UL upgrade from UL 498 to UL 60320-1.

Product Change Notification					2576 Change of marking		
owner	creation date	release date	released by	change order no	rev	page	D10-055-674
zeierjo	31.03.2021	31.03.2021	muehlema	2021023	B	1 of 2

3 Detailed description of change

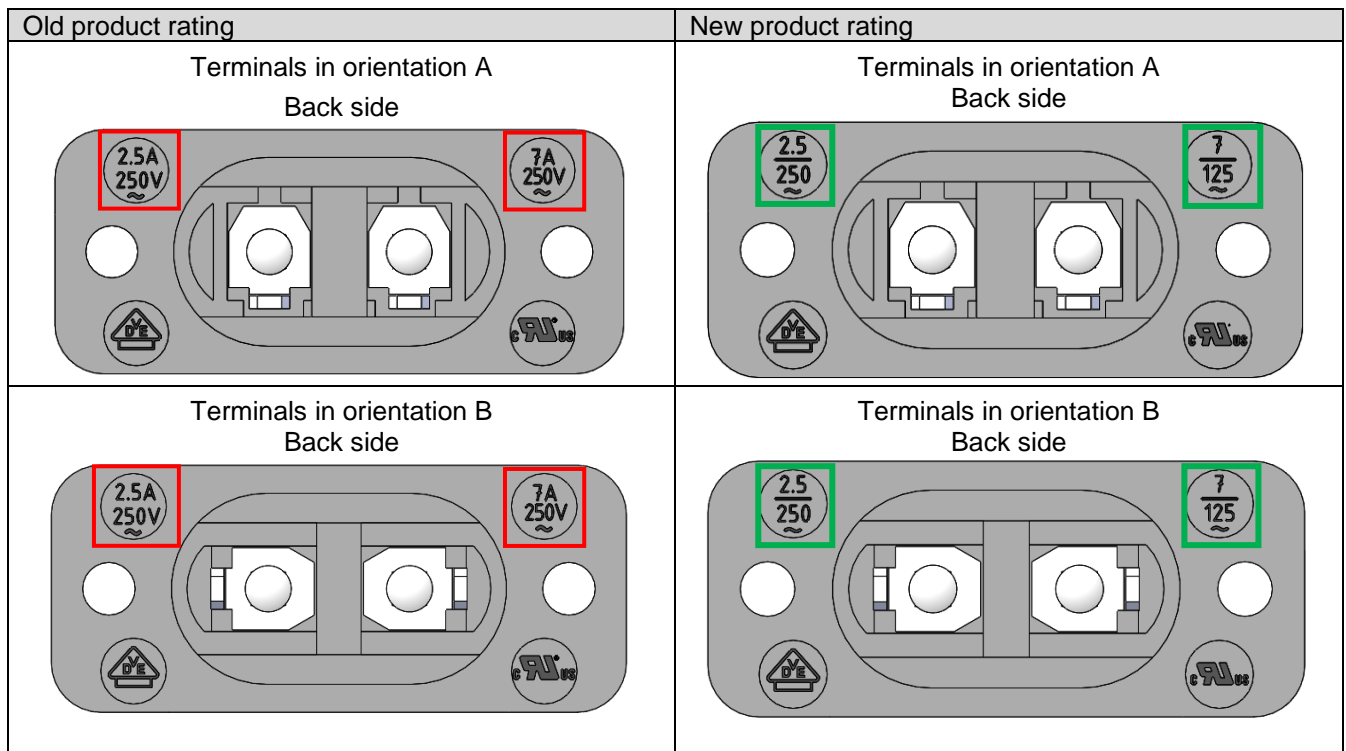
Marking for UL rating 7A/125V~ updated. Marking for IEC rating 2.5A/250V~ updated.
